99-2, *Publication Date: JANUARY 26, 1999*

Tire - Excessive Wear On One Front Tire - Vehicles Built Through 12/1997 Equipped With 14600, 16000, 18000 Or 20000 lb Front Axle	Article No. 99-2-7
--	-------------------------------

MEDIUM/HEAVY TRUCK:

Figure 1 - Article 99-4-4

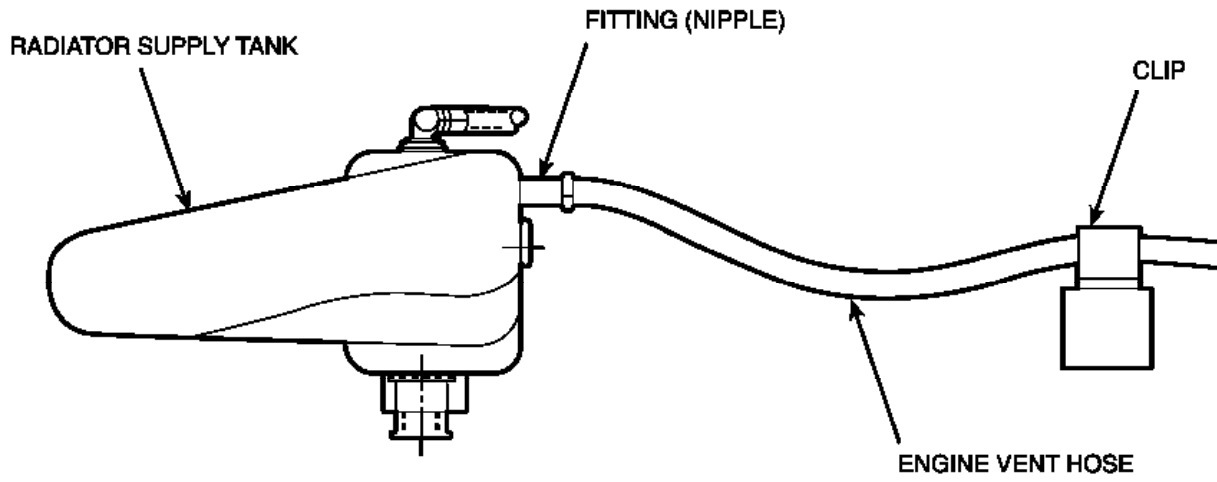
The radiator coolant supply tank vent hose nipple may break off at the tank connection. Engine vent hose routing may allow the engine to pull on the tank nipple during engine articulation.

1. Replace the coolant supply tank and associated hardware. Refer to the appropriate Louisville/AeroMax Workshop Manual, Section 303-03, or Service Manual, Section 03C-03.
2. Loosen the engine clip as necessary where the engine vent hose line is routed through and add 25.4mm (1") slack between the hose clip and the coolant tank nipple. The vent hose is sufficiently long to allow the 25.4mm (1") slack. Refer to «[Figure 1](#)».
3. Retighten engine clip to retain the vent hose.

Figure 1 - Article 99-12-10

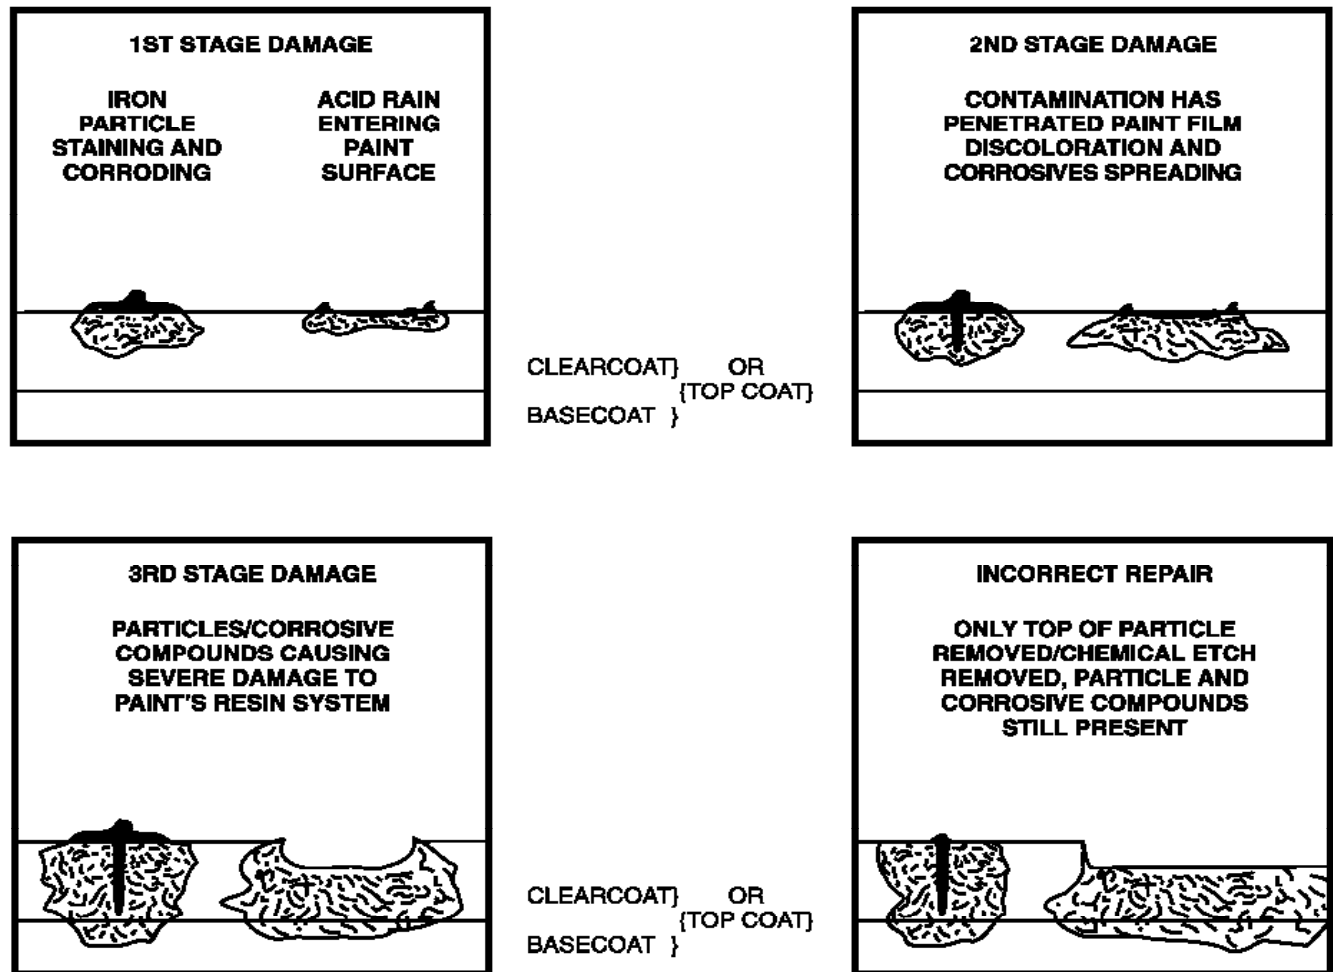
Studies conducted have shown the use of Oxalic Acid ferrous metal removers actually contribute to further damage of the paint's resin system, creating long term damage, which may not be evident for months. Additionally, Oxalic Acid products may damage soft exterior trim, aluminum trim and soften the paint.

The use of "clay" type products does not remove the entire ferrous particle or environmental contamination. Clay removes only the top of the particle and stain generated by the contamination, leaving the particle imbedded and the corrosive chemical compounds generated by the contamination in the paint system.

The particles and/or chemical compounds are still present and they continue to generate damage. Color sanding, buffing, or compounding the paint film to remove ferrous metal, industrial fallout, or acid rain damage may not remove the entire cause of the damage (they treat only the symptom and not the cause). The chemical compounds are still in the paint system and will continue to damage the paint. Color sanding and buffing may result in excessive removal of clearcoat film. Removal of OEM clearcoat in excess of 0.3 mil may contribute to premature clearcoat failure and is not recommended.

THE DECONTAMINATION PROCEDURE DIRECTED IN THIS BULLETIN MUST BE PERFORMED BEFORE ANY BUFFING, POLISHING, COLOR SANDING, OR REFINISHING IS ATTEMPTED.
